Index 653-001 Pedestrian Control Signal Installation Details

COMMENTARY

The TERL has received multiple questions from Contractors regarding clarification of grounding requirements for pedestal poles. This update is to help clarify requirements to reduce future questions. Corresponds with Specification update to 620-3.3.

LAST REVISION 11/01/25	REVISION	DESCRIPTION:	 FY 2026-27 STANDARD PLANS	PEDESTRIAN CONTROL SIGNAL INSTALLATION DETAILS	INDEX 653-001	SHEET 1 of 1
---------------------------	----------	--------------	---	---	------------------	-----------------

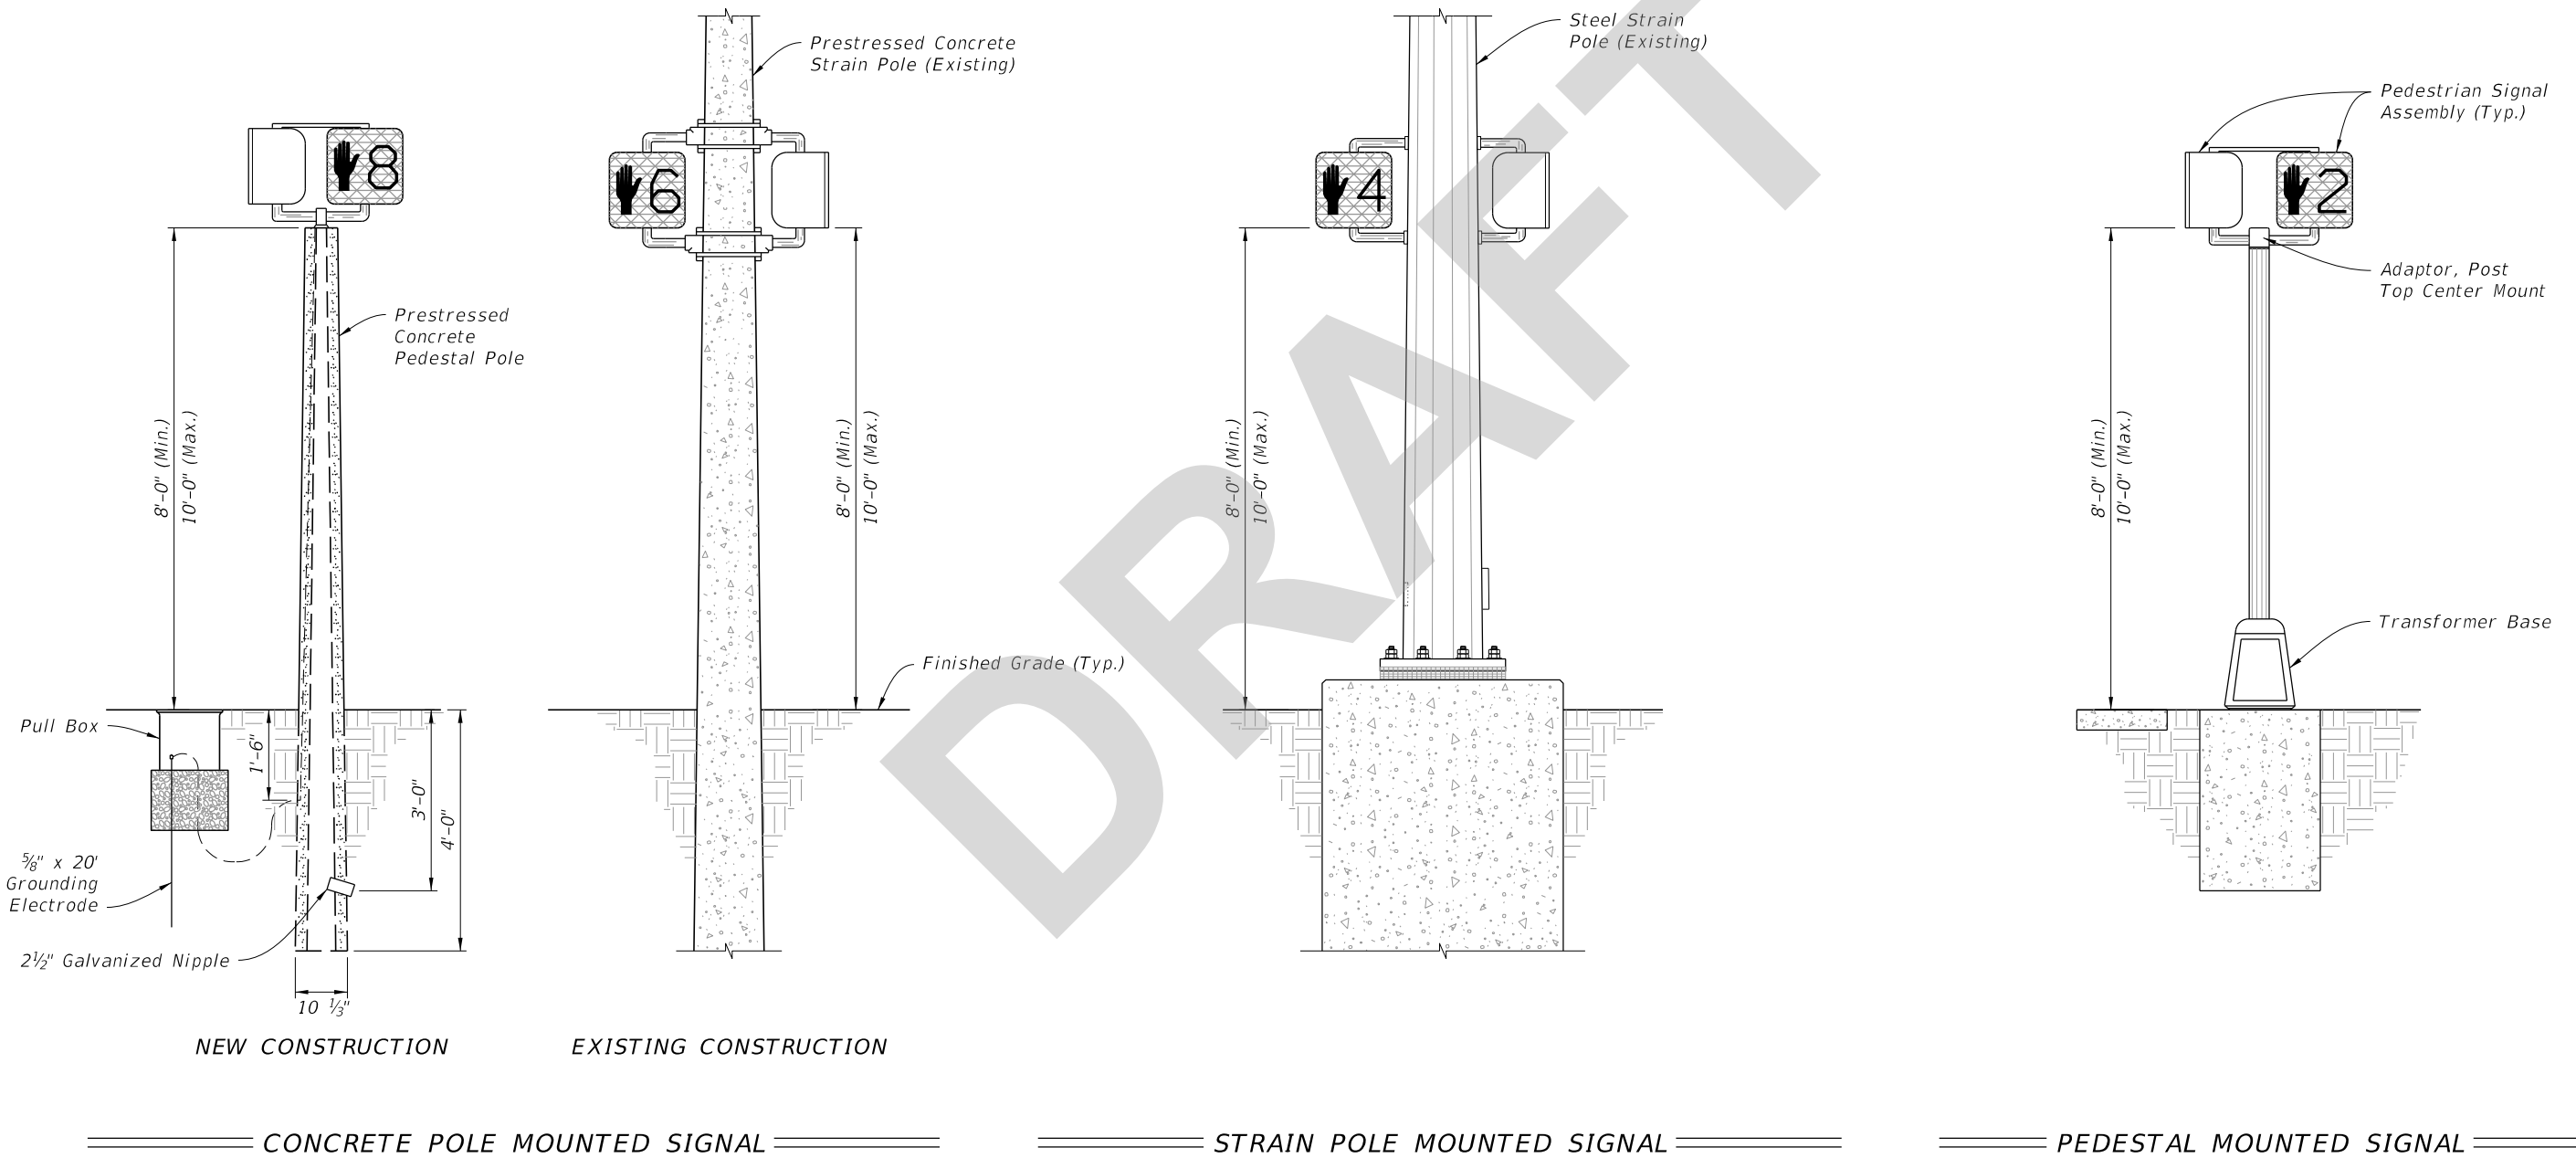
COMMENT: For the Pedestal Mounted Signal Detail, should the ground electrode conductor be shown to terminate onto a ground lug mounted on the wall of the transformer base? Also, should the ground conductor of the pedestrian signal head from the cabinet be shown to be terminated onto the ground lug? All metal components of the system, including the pole itself, will then be bonded together to create a continuous grounding network, including the grounding wire from the pole to the ground bus inside the traffic signal cabinet.

COMMENT: For the Concrete Pole Mounted Signal Detail, should the ground electrode conductor be shown embedded in the pole as shown in Index 641-010 rather than inside the pole cavity?

COMMENT: The pull box configuration for the Pedestal Mounted Signal is shown in Standard Plans Index 646-001. I would suggest not showing it in multiple places as this could cause confusion. Also, the Electrode Wiring is shown in the void of the pole in the Concrete Pole Mounted Signal. I do not believe this is the correct way to show it.

RESPONSE: The depiction in the Index is not intended to provide the details of specific connection types and locations as this may vary. However, we do recognize the potential issue and we will add a note to Index 646-001 that states: "For pedestal mounted signals, route and terminate the grounding electrode conductor to a ground lug within the transformer base". This will have to wait until next cycle as we did not make any revisions to Index 646-001 this cycle.

The pedestrian signal is typically wired using 3 conductors (neutral, walk, don't walk). Depicting an additional bond directly between the signal and the pole ground lug is not advised.

RESPONSE: Thank you for your comment. This will be considered for next cycle.

RESPONSE: Thank you for your comments. Yes I agree that most of the information is shown in Index 646-001. We will delete the newly proposed pull box detail. We will revise General Note 7 to ensure the users know to look in Index 646-001. We will also revise the Electrode Wiring in the pole.
